Lodz, Poland, 7th August 2020

We thank you for the time and comments. In the lines that follow, we will do our best to reply to the comments and propose improvements for the final manuscript. At first, we focus on the comments that were posted in the text of the manuscript. Secondly, the general comments from the cover letter will be answered.

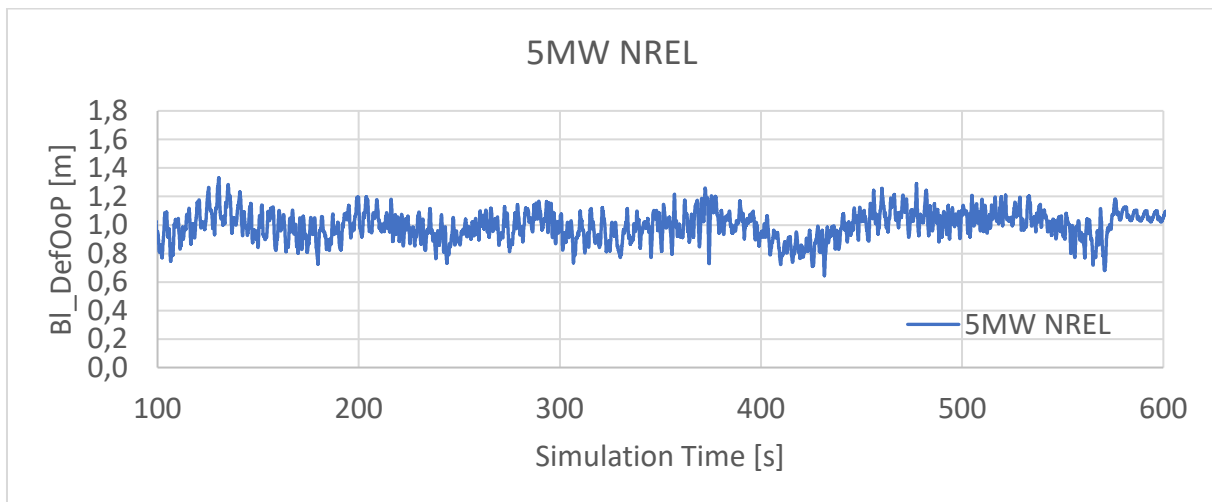
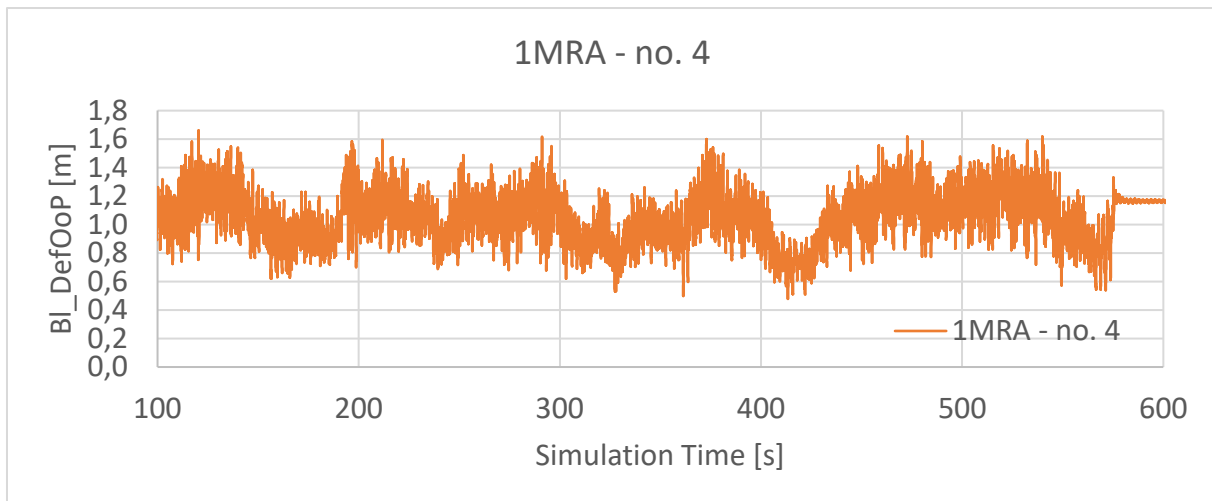
Reply to Reviewer's comment #16 pg. 12 right imprint of Fig. 7: The normalised amplitudes for the tip deflection of the single large rotor and the no. 4 rotor of the MRS are presented below.

Figure 37. Availability results for the semisubmersible substructure

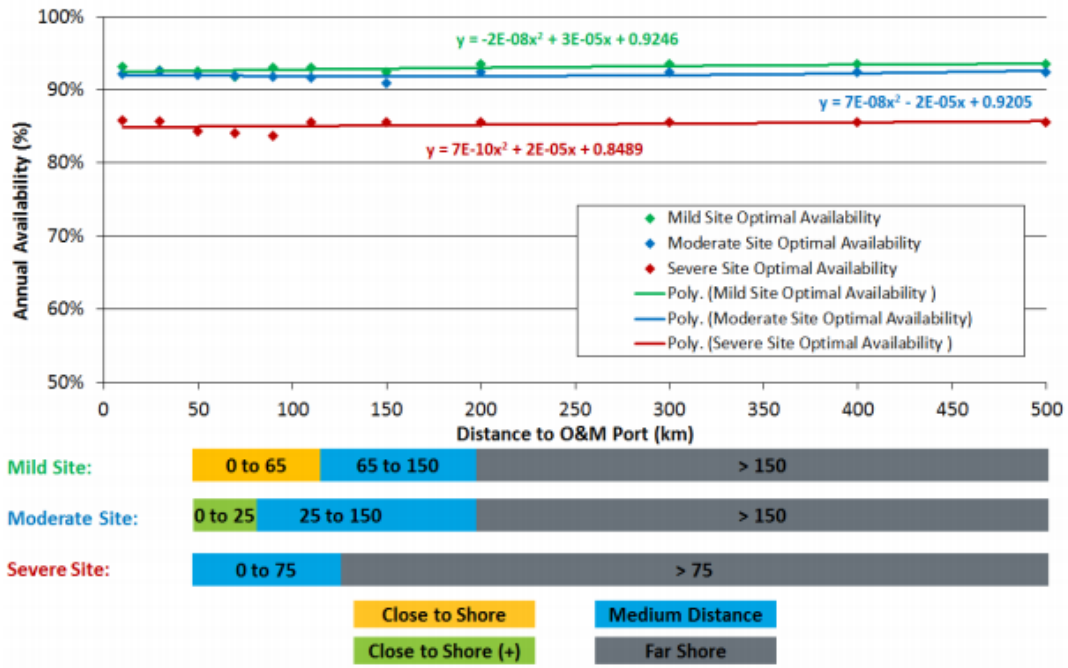
In practicality, any transfer time above 2hr to an offshore site is considered usually a far shore project. So combining the site class and distance to ports, one may derive O&M strategy and costs, for example as below (2 figures A and B from the above NREL report are provided). The plots are made for quay-side maintenance performed in port, to which the floating turbine is towed rather than in-situ repair. ECN recommends that for heavier replacements (spare parts above >3 MT). The regular corrective and condition based O&M is performed by a small service operating vessel (SOV) or a mother operating vessel (MOV), but it may largely depend on conditions at sea around turbine site but also en-route to the location.

The above USD/kW estimates are a bit underrated, especially for a still relatively new concept – a single rotor floating wind turbine, much more in regards to placing a floating MRS. For the financial model that was used in the paper, to price O&M of an innovative floating turbine for Baltic Sea, the authors arrived at O&M of 77 EUR/kW, over 2.5 times more than reported in the strategy proposed by NREL.

Figure 36. OpEx results for the semisubmersible substructure

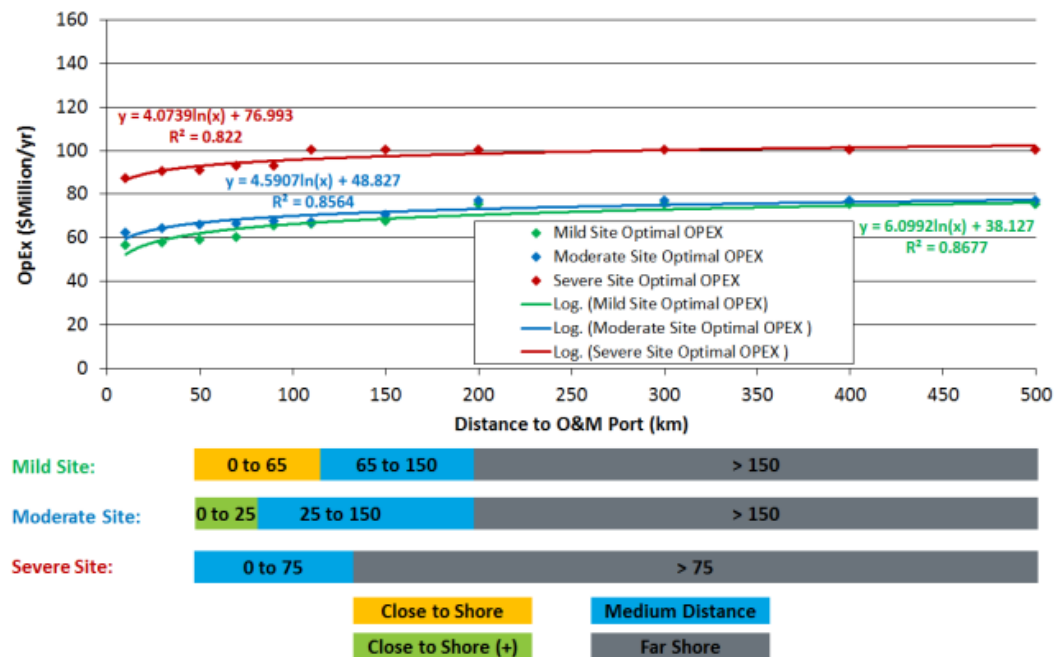
Figure B. OpEx results for the semi-sub floating turbine, the amounts are based for a generic 3.4 MW floating offshore unit -> Opex/kW is 100 mln USD/3.4 MW = 29.41 USD/kW
